ADDENDUM # 02

Building & Site Enhancements

John Jay Homestead State Historic Site

Project ID: TA-JJ-2023-01

Drawing No: L-503

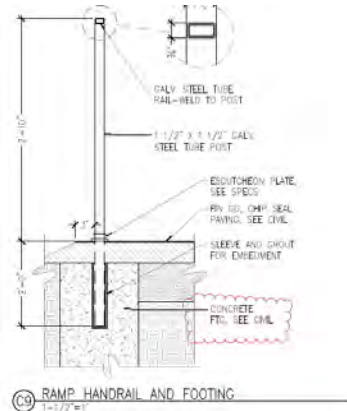
Detail C9/L-503 ("*Ramp Handrail and Footing*") references the civil drawings for details on the concrete footing however, the civil drawings do not include footing diameter, depth, reinforcing etc. Please clarify.

Company Name	Response	Reviewed At
Beyer Blinder Belle Architects & Planners	Please refer to the response from CHA Consulting and Rhodeside & Harwell.	09/11/2024
Rhodeside & Harwell Inc.	RHI agrees with CHA's response	09/11/2024
CHA Consulting	Concrete footings shall be constructed per detail C9/L-503 using 12" diameter, 4.5' deep, and 3,000 psi concrete	09/09/2024

Drawing No: C-501, L-503

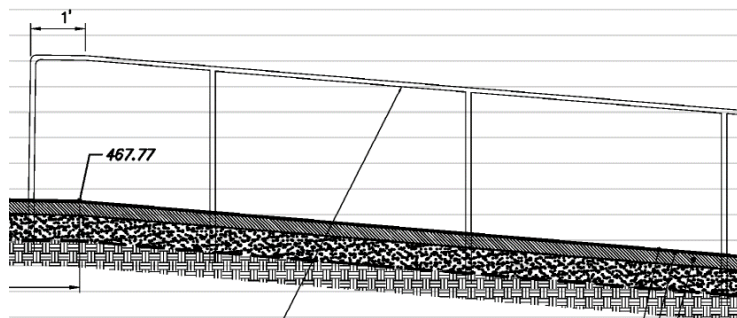
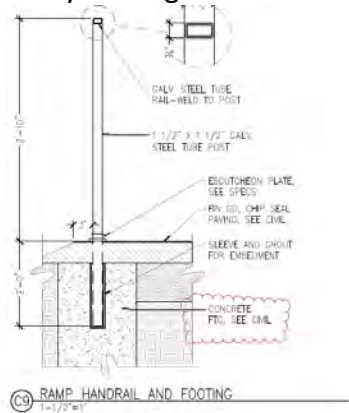
Detail C9/L-503 shows a concrete footing at the railing posts however, the ramp profiles do not indicate any footings. Please clarify.

Company Name	Response	Reviewed At
Beyer Blinder Belle Architects & Planners	Please refer to the response from CHA Consulting and Rhodeside & Harwell.	09/09/2024
Rhodeside & Harwell Inc.	RHI agrees with CHA's response.	09/09/2024
CHA Consulting	Concrete footings shall be constructed per detail C9/L-503 using 12" diameter, 4.5' deep, and 3,000 psi concrete	09/09/2024
